NUMBER: 09-003-19

GEN-2 and GEN-3 - 3.0L Oil Filter Cartridge Identification Differences

This bulletin highlights the design differences in the oil filter cartridges used in the GEN-2, and GEN-3 3.0L diesel. As well as potential issues that can arise should the incorrect filter be used in each application.

Fig. 2
Fitment of Oil Filter Cartridges in the Cap

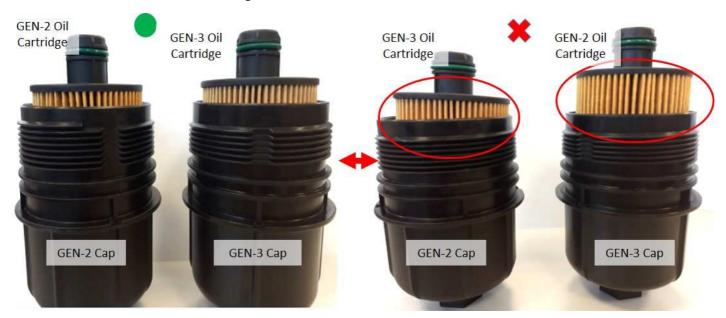
If a GEN-2 engine design filter element is used in a GEN-3 engine filter cap, or the GEN-3 engine element is used in a GEN-2 engine filter cap, it will lead to unfiltered oil to be circulated through the engine leading to premature wear (Fig. 2):

- Correct fitment of the cartridge in green.
- Incorrect fitment of the cartridge RED X.
